WBN-TS-03-12

**WATTS BAR NUCLEAR PLANT (WBN) – LICENSE AMENDMENT (WBN-TS-03-12)
MONITORING OF CONTROL OR SHUTDOWN ROD POSITION BY AN ALTERNATE
MEANS - REQUEST FOR ADDITIONAL INFORMATION (RAI) (TAC MC 1419)**

**PROPOSED LICENSE AMENDMENT REQUEST WBN-TS-03-12
RESPONSE TO NRC'S REQUEST FOR ADDITIONAL INFORMATION (RAI)
RECEIVED BY TVA ON MAY 26, 2004**

Figure 1
Example of Wiring for the Monitoring of Rod Control System Parameters
Example Based on Control Rod E-5

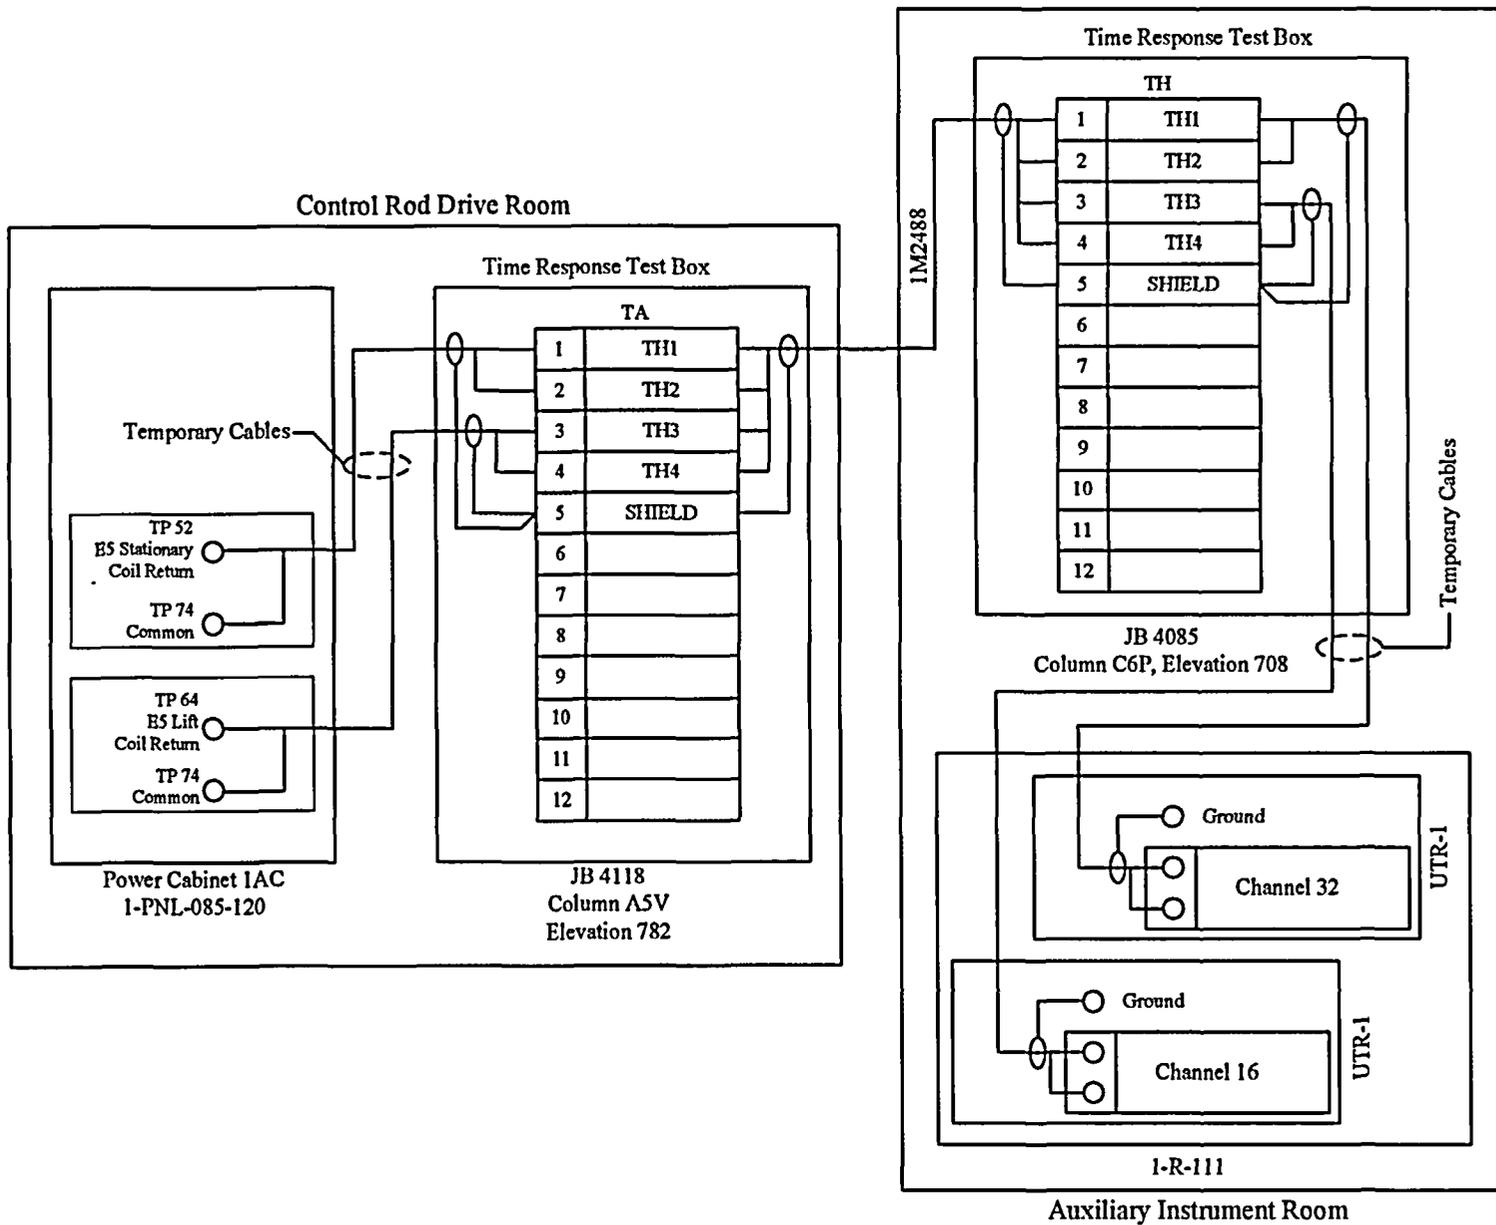
The proposed REQUIRED ACTION A.2.2 requires to review the parameters of the stationary gripper coil for indications of unintended rod movement for the rods with inoperable position indicators within 16 hours and once per 12 hours thereafter. Actual Technical Specifications, REQUIRED ACTION A.1, requires the verification of the rod position with inoperable position indicators every 8 hours. That is, the intention of the actual REQUIRED ACTION A.1 is to provide the position of the affected rod every 8 hours. However, the proposed monitoring method will verify the rod position every 12 hours once the position is established with the incore detectors. The NRC staff requests the licensee provide technical justification for the 12 hours frequency of the proposed action A.2.2.

The proposed rod position monitoring method intends to monitor the rod control system parameters for indication of "unintended" rod movement for the rods with inoperable position indicators. The NRC staff requests the licensee provide a technical justification of why the rod position will be monitored with the incore detectors only in case of unintended rod movement. Please provide the justification of why the rod position does not need to be verified using the incore detectors if the rod is intentionally moved.

In order to monitor if the affected rod stepped in the direction that was demanded, the method of implementing the alternate means has been modified. Figure 1 (below) documents the changes that were made to the monitoring circuit which adds the capability to monitor the current of the lift coil using a circuit similar to the circuit used to monitor the stationary gripper coil. The timing of the lift coil energizing will be analyzed by a software algorithm, and compared to demand signals generated by the rod control system to determine if the rod stepped in the direction demanded.

For any of the following three situations, the software algorithm will generate a plant computer alarm:

1. The rod stepped in the wrong direction.
2. The rod stepped with no demand (whether in automatic or manual control).
3. The alternate monitoring circuit fails.

Once an alarm is received, Required Action A.2.1 is applicable and the position of the rod will have to be determined within 8 hours of the alarm by use of the incore detectors. In addition, the computer alarm generated by either of the first two conditions may be accompanied by a rod control system urgent alarm which is annunciated in the main control room.
